FEASIBILITY STUDY OF A STORAGE COOLING SYSTEM
FOR DEFENSE MEGACENTER (BLDGS 350 & 390)
AT ROCK ISLAND ARSENAL, IL

Principal Investigator
Chang W. Sohn, Ph.D., P.E.

24 July 96

Figure A1. Site map showing location of Bldgs 348, 350, and 390.

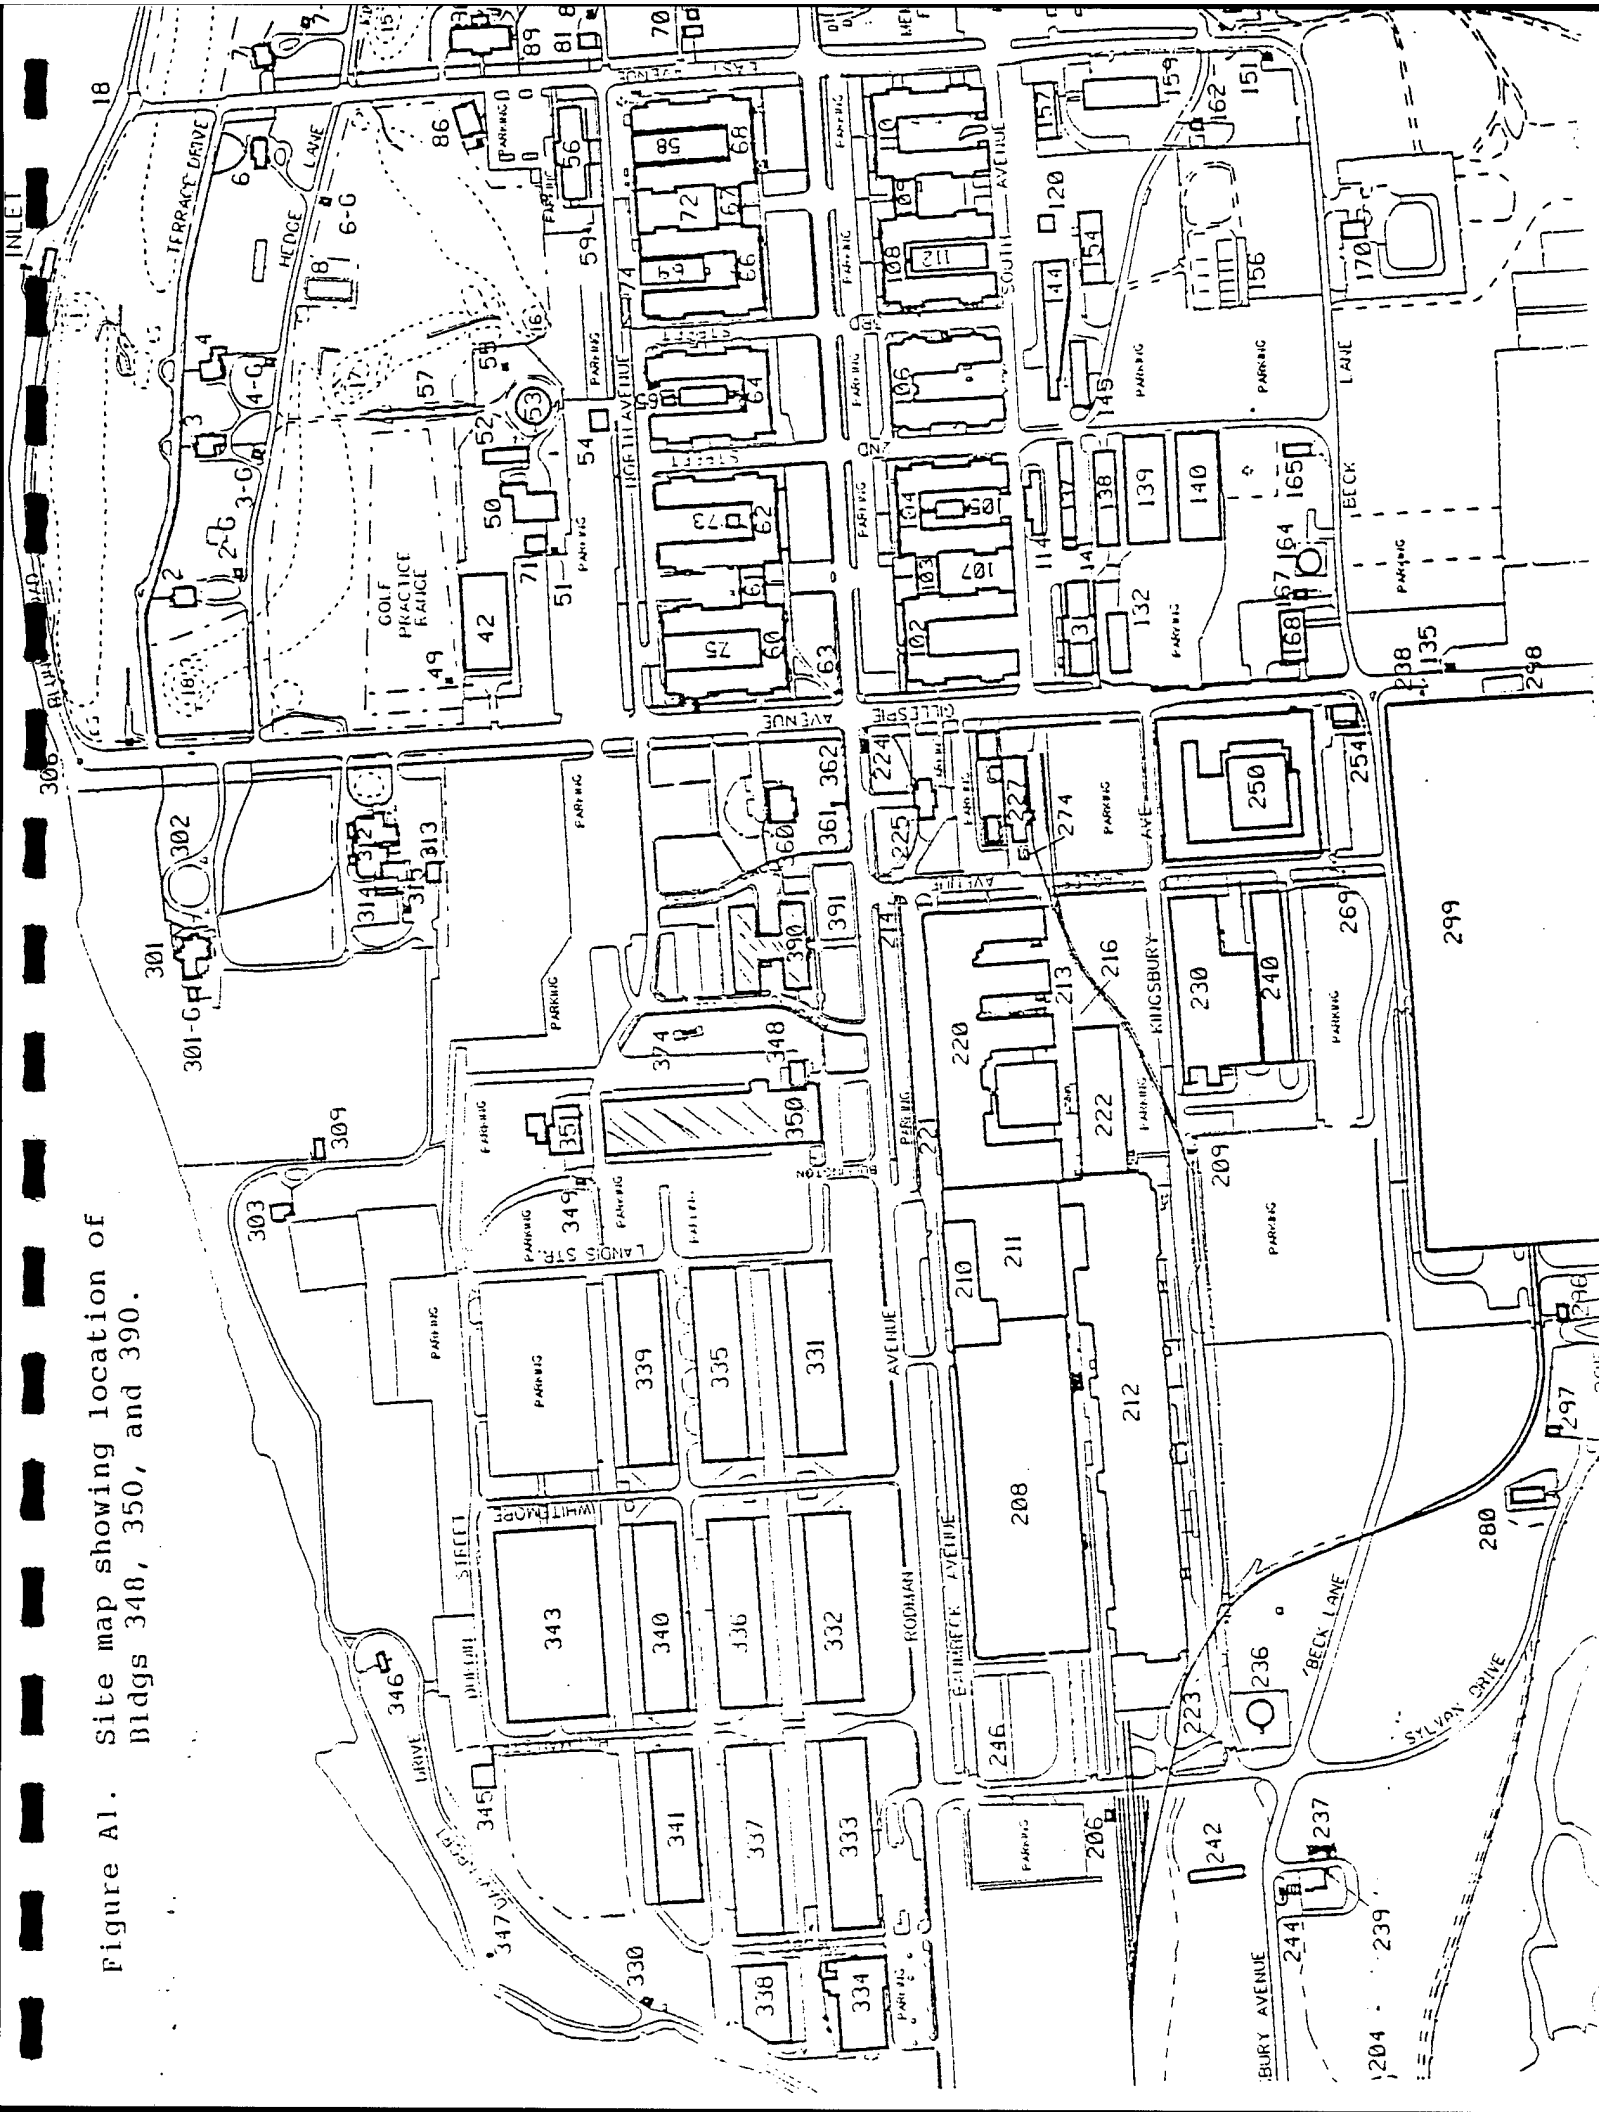
Q: A location map showing where these two buildings are at on RIA in the report would help others at a later time in referencing the buildings. If you have photos could they have been utilized to show the existing units along with their data identification information, or building facade? Sometimes those persons who can't physically go to the site for mechanical inspections could readily obtain information from photos.

R: Appendix B has been added that includes both a site map and photographs.
